Access Compliance Report

Public Rights-of-Way

(Curb Ramps)

Intersection ID: N/A	Main Street: E 8TH ST	Cross Street: N BREVARD ST	Location: W
ADA ID: ABC67F547B0C	Ramp Type: Perp	Initial Pass/Fail: Fail	Overall Compliance: No
Severity Score: 21.25			
Codes/Mitigation Info/Possible Solution		Field Measurements/Component Compliance

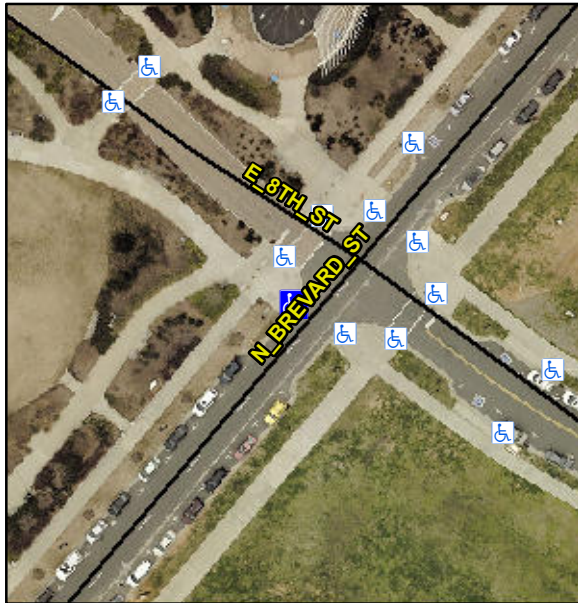
Not Found, R304.5.1, R304.2.2

Compliance	Description	Data	Compliance	Description	Data
N/A	Ramp Length (in)	71.0	No	Ramp Slope (%)	8.5
No	Ramp Width (in)	45.0	Yes	Ramp XSlope (%)	1.5
N/A	Flare Type LT	N/A	N/A	Flare Type RT	N/A
N/A	Flare Slope LT (%)	N/A	N/A	Flare Slope RT (%)	N/A
N/A	Flare Traversable LT?	No	N/A	Flare Traversable RT?	No
N/A	Landing Length (in)	N/A	N/A	DWS Provided?	N/A
N/A	Landing Width (in)	N/A	N/A	DWS Contrast?	N/A
N/A	Landing Slope (%)	N/A	N/A	DWS Length (in)	N/A
N/A	Landing X Slope (%)	N/A	N/A	DWS Full Width?	N/A
N/A	Landing Curb? (Y/N)	N/A	N/A	DWS Offset (in)	N/A
N/A	Shared Landing?	N/A			
N/A	Gutter Ponding?	N/A	N/A	Gutter Slope (%)	N/A
N/A	Gutter Lip Ht (in)	N/A	N/A	Gutter X Slope (%)	N/A
N/A	Painted X Walk1?	No	N/A	Painted X Walk2?	N/A
	X Walk 1 Direction	To SE		X Walk 2 Direction	N/A
N/A	X Walk 1 Width (in)	N/A	N/A	X Walk 2 Width (in)	N/A
	X Walk 1 Slope (%)	1.4		X Walk 2 Slope (%)	N/A
	X Walk 1 X Slope (%)	0.2		X Walk 2 X Slope (%)	N/A

Remove & Replace Entire Ramp.
